OIL CONSERVATION DIVISION

WELL API NO.	30-025-36788 ✓
5. Indicate Type of Lease	STATE <input type="checkbox"/> FEE <input checked="" type="checkbox"/> ✓
6. State Oil & Gas Lease No.	
7. Lease Name or Unit Agreement Name	ROBINSON ✓
8. Well Number	1 ✓
9. OGRID Number	021602 ✓
10. Pool name or Wildcat	NADINE-BLINEBRY EAST ✓

SUNDRY NOTICES AND REPORTS ON WELLS
(DO NOT USE THIS FORM FOR PROPOSALS TO DRILL OR TO DEEPEN OR PLUG BACK TO A DIFFERENT RESERVOIR. USE "APPLICATION FOR PERMIT" (FORM C-101) FOR SUCH PROPOSALS.)

WELL BORE DIAGRAM ATTACHED - PROPOSED PLUGGING PROCEDURE

WELLBORE DIAGRAM

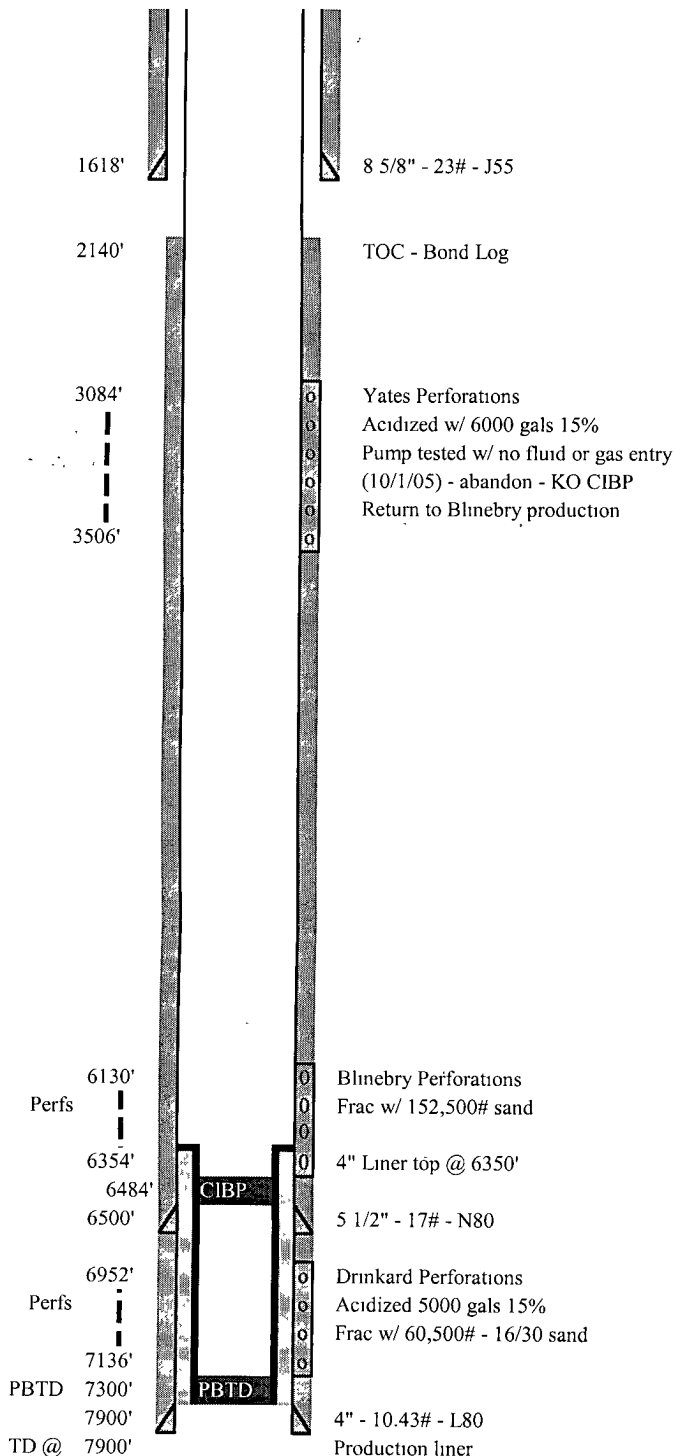
- 1) Set CIBP @ 6100' - dump bail cement
- 2) Set CIBP @ 3000' - dump bail cement
- 3) Cut off 5 1/2" casing @ 1800'-2000'
- 4) Set 100' cement plug across cut off - woc & tag
- 5) Set 100' cement plug from 1668' - 1568' - woc & tag
- 6) Set surface plug - install dry hole marker

60'
SET 100' CMT 350' - 250'
